From:	Connie Cunningham	
То:	City of Cupertino Planning Commission	
Subject:	23-3-28 PC Agenda Item 2, 19191 Vallco Parkway by Apple, Inc.	
Date:	Tuesday, March 28, 2023 2:40:45 PM

Subject: Agenda Item 2, Consider the proposed development at 19191 Vallco Parkway Project by Apple, Inc.

RE: 19191 Vallco Parkway Project

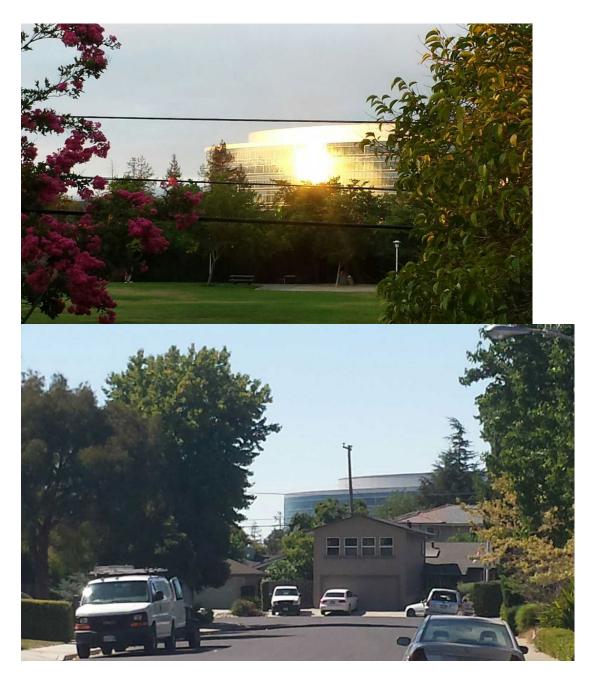
Majority glass buildings create glare and light trespass. Santa Clara home owners/residents, Residence Inn and potentially loft apartments could all suffer from that.

Some older examples of this - attached photos show the occupied leased office building on SCBlvd. It's 'twin' is not yet occupied. I was unable to find all of the photos I hoped to include
